Technical Bulletin

ILS zoom ring clearance issue

This bulletin provides information about a zoom ring clearance issue on the Zoom Motor (P/N: 003-202552-XX) and Zoom Hardware (P/N: 003-007515-XX) kits involving the lenses listed below.

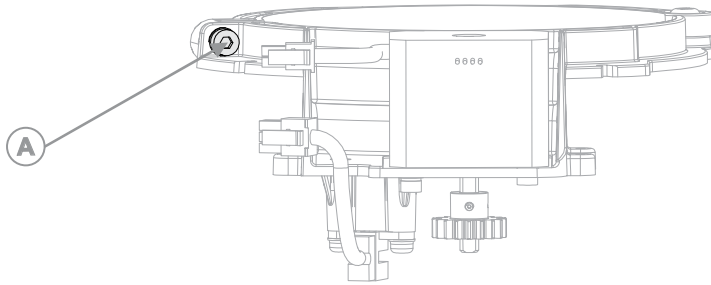
When using the ILS Zoom Motor and Zoom Hardware kits with the lenses listed below, an obstruction occurs preventing smooth operation of the zoom ring.

1. Order black rubber tape (P/N- 5577N27) from the McMaster-Carr® website: <https://www.mcmaster.com/catalog/130/4065/5577N27>.
2. Cut two 12 cm (4.7 inches) pieces of the tape ordered in step 1.
3. Remove the backing of one piece of tape and attach it to the zoom motor mounting bracket (P/N: 011-110829-XX) in the location shown.

Align the end of the tape with the highlighted edge of the zoom motor mounting bracket.
